RESPONSE TO SECTION 70 COMMENTS

Project	Delmore Residential Development, FTAA-2512-1164
Subject	Westlake Trustee Limited section 70 comments, section 4.7: third party servicing and reserved capacity (wastewater and water supply)
Prepared by	James Kitchen CMEngNZ, CPEng, Project Director, McKenzie & Co. (third party servicing, wastewater); water supply conclusions by Romeo Dela Cruz CMEngNZ, CPEng, McKenzie & Co. (water reticulation)
Reviewed by	James Kitchen CMEngNZ, CPEng, Project Director (water supply section); Clayton McKenzie, Managing Director (governance review); planning and legal conclusions to be settled by the applicant's planning and legal advisers
Date	4 August 2026

Figure 6-3: Orewa West Wastewater Servicing. Source: PC119 Appendix K, Engineering Report (Crang Civil), Section 6.3. Red star indicates Delmore, orange star indicates 35 Russell Rd, placed over image by McKenzie & Co.

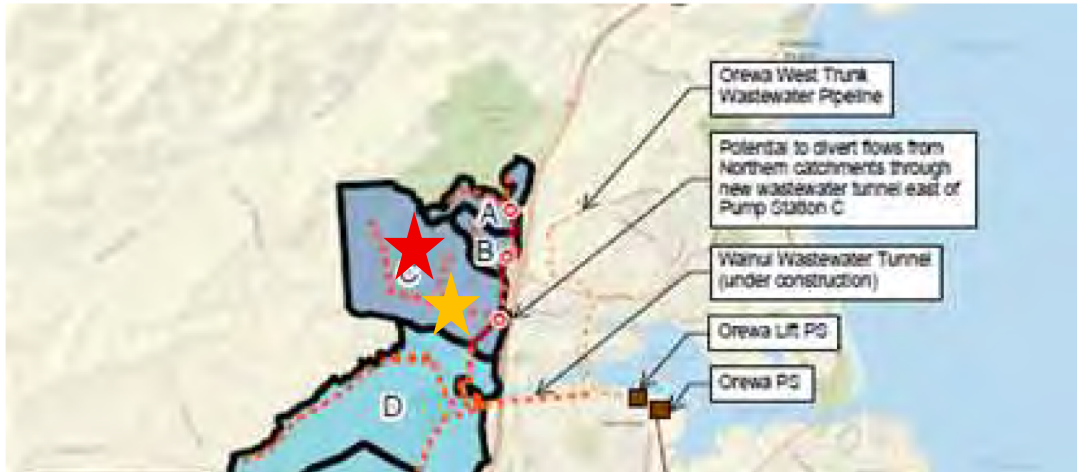
The comments seek a condition requiring physical connection points and reserved processing and hydraulic capacity in the WWTP, the WTP and associated infrastructure and networks for 35, 11 and 3 Russell Road, with legal connection mechanisms (Gardiner memorandum, 27 July 2026, section 4.7). Section 1 of this paper addresses the wastewater component; section 2 addresses the water supply component.

The Ara Hills plan change engineering report (PC119 Appendix K, Crang Civil, Section 6.3, Option 2) identifies a future public network pathway in which the area's wastewater flows would drain south to the Wainui Wastewater Tunnel, and records that this option provides servicing to future urban areas. It is an identified future pathway in the public record, not a presently available or committed connection. Capacity allocation, timing, funding and connection approval for that pathway remain matters for Watercare, the Council and future structure planning and consenting processes.

Figure 6-3 below is reproduced from PC119 Appendix K at the highest resolution available from the source document, retaining its original title and annotations. It distinguishes existing from future infrastructure and demonstrates an identified servicing pathway; it is not a presently guaranteed Watercare connection or capacity entitlement.

The public servicing material identifies a future southern public wastewater pathway for the wider future urban area that does not rely upon the Delmore private wastewater system. Accordingly, the absence of reserved capacity or physical connection points within Delmore's wastewater system does not, of itself, preclude future servicing of 35, 11 and 3 Russell Road.

Condition consequence: from an engineering perspective, we do not recommend conditions requiring Delmore's private wastewater system to reserve treatment or hydraulic capacity, or provide physical connection points, for third party land. No engineering need for those requirements has been identified in relation to the Delmore servicing scheme. Future catchment servicing and the allocation of public network capacity and costs should be addressed through the relevant Watercare and Council processes.
